Product Change Notice (PCN)

PCN Number: **PCN-0450734R-01**

Product(s) Affected: **PJ-014CH-SMT-TR**

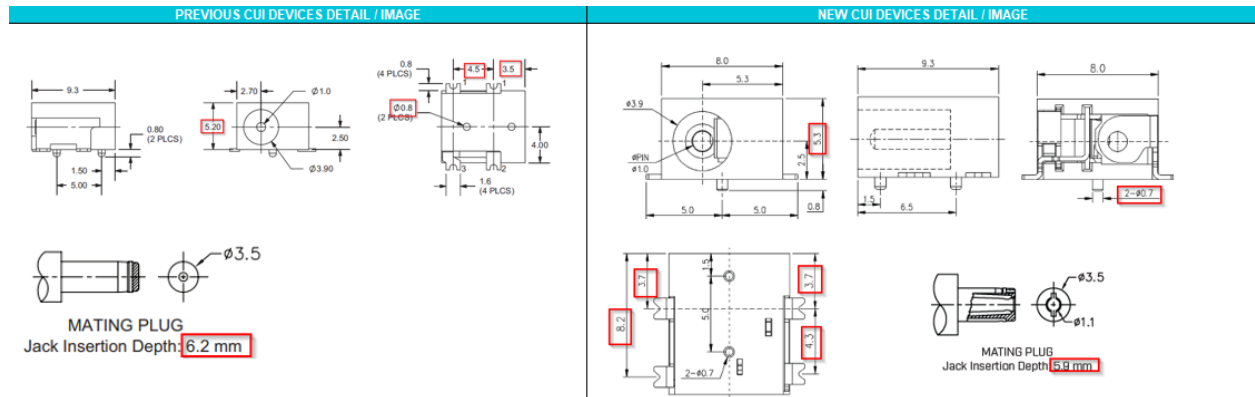
Description of Change: **Mechanical, electrical, and material changes as shown below:**

MATERIAL	PLATING
center pin	copper	nickel
terminal 1	brass	silver
terminal 2	copper alloy	silver
terminal 3	brass	silver
plastic	PA6T or equivalent

DESCRIPTION	MATERIAL	PLATING/COLOR
center pin	brass	silver
terminal 1	brass t=0.50	silver
terminal 2	bronze t=0.25	silver
terminal 3	brass t=0.50	silver
housing	PA1DT (UL94V-0)	black
